<b>LHC-DFBX</b> PO. No.		<h1 style="margin: 0;">Deviation Request</h1>		<b>DR - 014</b>
		Routine		Date: Nov 5, 2004
To LBNL DFBX Project Manager:		Supplier Name, Address, Phone, etc:		
Joseph Rasson		LBL Shops/ Jon Zbasnik		
Type: Subassembly

Item Name and Serial Number	DWG #	QTY Nonconforming Items		
MQX1, 25I448-5	25M857	1		
Description of Deviation      See attached <input type="checkbox"/>		Requirements Violated      See attached <input type="checkbox"/>		
<p>There are 2 crossovers in the corrector busses. The crossovers occur in the first bend out of the lambda plug. A4A and B4B are interchanged, as are H1A and H1B.</p> <p>The crossovers are in region where little motion is expected to occur, because of a spider located very near to the bend.</p>		<p>The interchanged busses cross over each other and do not form a smooth, single-axis bend.</p> <p>With a lot of motion, the buss insulation could wear away, resulting in a short circuit.</p>		
Originator	Date	Principal Supplier Planner	Date	
Jon Zbasnik	Nov 5, 2004			
Remedial Action/Justification      See attached <input type="checkbox"/>		Cause and Corrective Action      See attached <input type="checkbox"/>

**6 June 2003**Pro

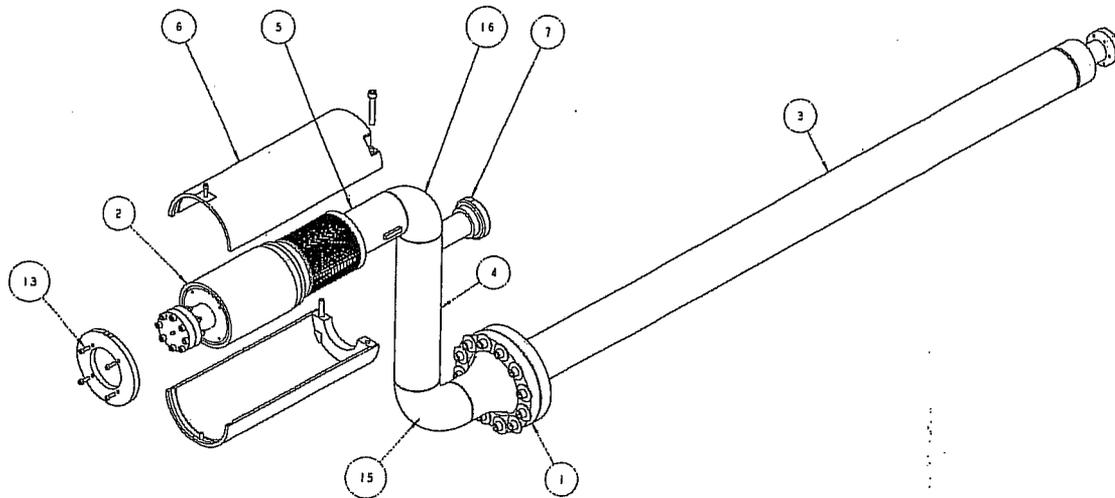
<p>Recommend to use as is. Because of the spiders, very little motion is expected to occur and the possibility of an electrical short is very remote.</p>		<p>This was the first MQX1 assembly, and the problem was detected after the conductors were bent and soldered into position. Subsequent MQX1's were checked before soldering.</p>		
<b>Prime Contractor Approvals</b>				
Recommended Disposition		Cost / Schedule Impact		
Accept <input checked="" type="checkbox"/> Redesign <input type="checkbox"/> Reject <input type="checkbox"/> Repair <input type="checkbox"/>		None		
	Date		Date	
Joseph Rasson	1/20/05

Customer Disposition: Accept Request <input checked="" type="checkbox"/> Deny Request <input type="checkbox"/> See attached <input type="checkbox"/>			
Technical Representative	Date	LBNL DFBX Project Manager	Date
Joseph Rasson	1/20/05	Joseph Rasson	1/20/05
Procurement Representative	Date
